I. Regulation No. 6 - 5.6 (c)

Problem: How to interpret the ‘One Continuous Line’ requirement?

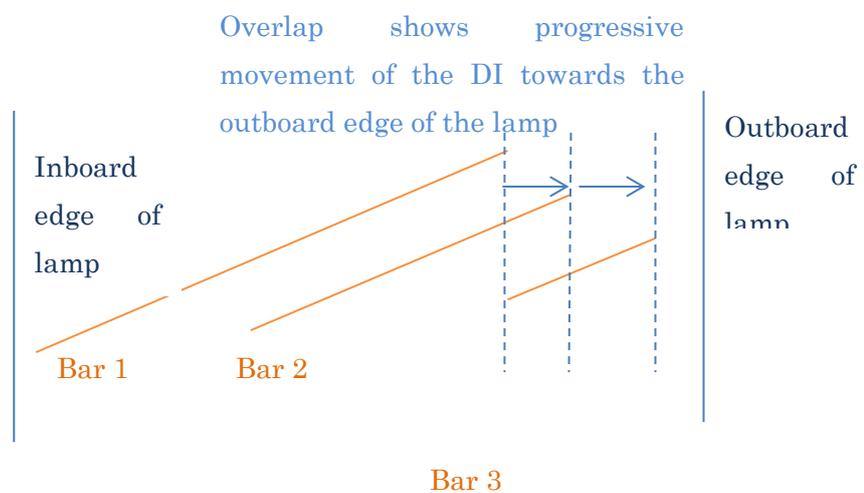
<p>Question</p>	<p>In the picture below the Direction indicator is Reciprocally incorporated with the DRL. Under operation of the D.I. the following occurs: All light sources within Bar 1 illuminates simulatneosly, followed by Bar 2 and then 3. There is no pulsation of the light sources within each bar.</p>  <p>The type approval authority (A) understands that a cycle consists of bar 1 illuminating all light sources within that bar simulatneosly, followed by Bar 2 and then 3. There is no pulsation of the light sources within each bar. The type approval authority (A) is trying to determine the rationale behind the approval of this lamp and in particular how it meets the requirements of paragraph 5.6 (c)</p>
<p>Relevant text or paragraph reference</p>	<p>5.6. For direction indicator lamps of categories 1, 1a, 1b, 2a or 2b the flash may be produced by sequential activation of their light sources if the following conditions are met:</p> <ul style="list-style-type: none"> (a) Each light source, after its activation, shall remain lit until the end of the ON cycle; (b) The sequence of activation of the light sources shall proceed in a uniform progressive manner from inboard towards the outboard edge of the apparent surface; (c) It shall be one continuous line with no repeating alternation in the vertical direction (e.g. no waves). (d) The variation shall finish no more than 200 ms after the beginning of the ON cycle; (e) For the orthogonal projection in the direction of the axis of reference of a rectangle,

The type approval authority (A) is trying to establish how to interpret the 'One Continuous Line' requirement. Has the above lamp been approved due to the overlap shown in the diagram below and therefore the lamp is seen as providing a continuous line in the direction from inboard to the outboard of the vehicle?

Or is there an alternative logic?

The intention is to establish a task force on "sequential activation". This task force should clarify the interpretation or formulate a working document for the 76th GRE to change R6.
